SUBJECT: MODIFICATION OF VACUUM BREAKERS ON
MARK I CONTAINMENTS (GENERIC LETTER 83-08)

Re: Brunswick Steam Electric Plant, Units 1 and 2

Request for Additional Information

Related to the Modification of Vacuum Breakers on Mark I Containment

Figure 2 Steps in determining plant unique vacuum breaker forcing functions

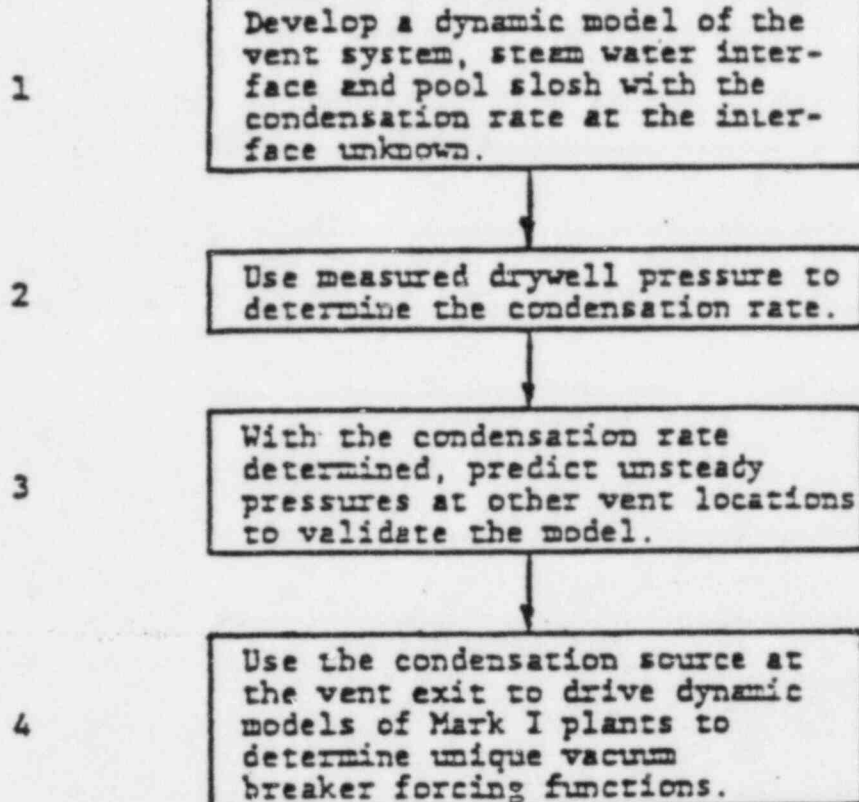
histories from the FSTF test facility. After transferring these condensation sources to a model of an actual Mark I plant, the analytical model would compute the pressure time history across the disk of the vacuum breaker. Figure 2, extracted from CDI report 84-3, provides the steps followed to determine the plant unique vacuum breaker forcing functions.
